This Service Information bulletin and attachment supersedes SI B51 16 15 **dated July 2015.**

Delivery Stop: Remove Engine Oil Label

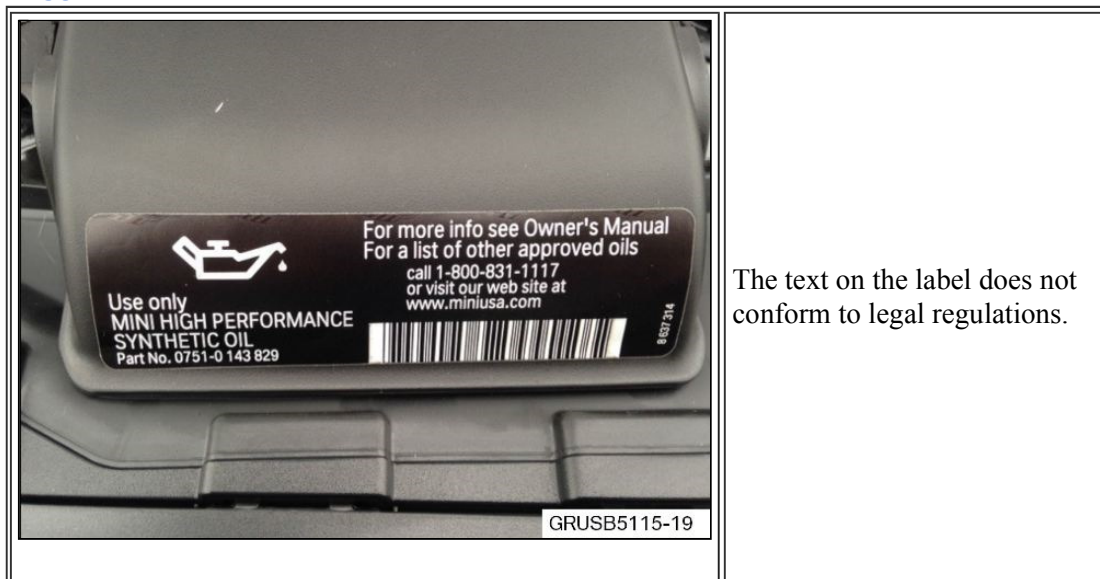
On affected vehicles, there is an incorrect label regarding the appropriate engine oil.

Remove the engine oil label (located in the front or rear of the hood).

Remove the label using a hot air gun to soften the adhesive. Gently pull the label off while varying the heat. Remove any remaining adhesive with solvent-based cleaner.
